SERVICE BULLETIN

TS-430S PLL UNLOCK AT HIGH TEMPERATURES (REVISION)

9-14-85

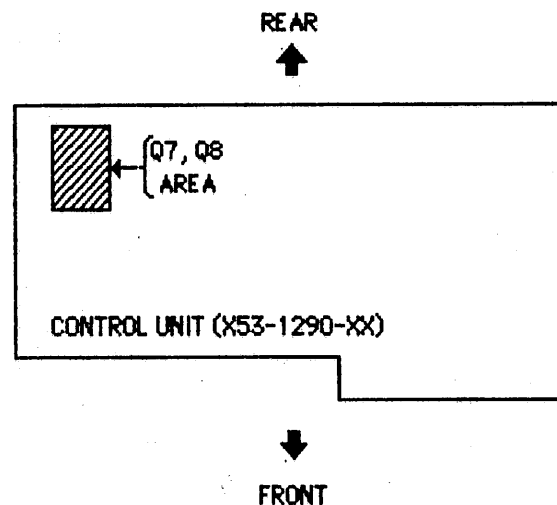
Check transistor Q8. If it is not a 2SC1815(Y) change it to this type (Serial numbers 408XXXX-509XXXX).

For serial numbers before 408XXXX change R29 to 820.0 Ω and C41 to 100 pF.

In addition to the changes listed above check for the following signals, (You must check these at a dial frequency of exactly 14.000.000 Mhz):

TP-1 6.0 volts (L-18 is the adjustment)

TP-2 70 Mhz

TP-3 45.3 Mhz

TP-4 6.35 volts (L10 is the adjustment)
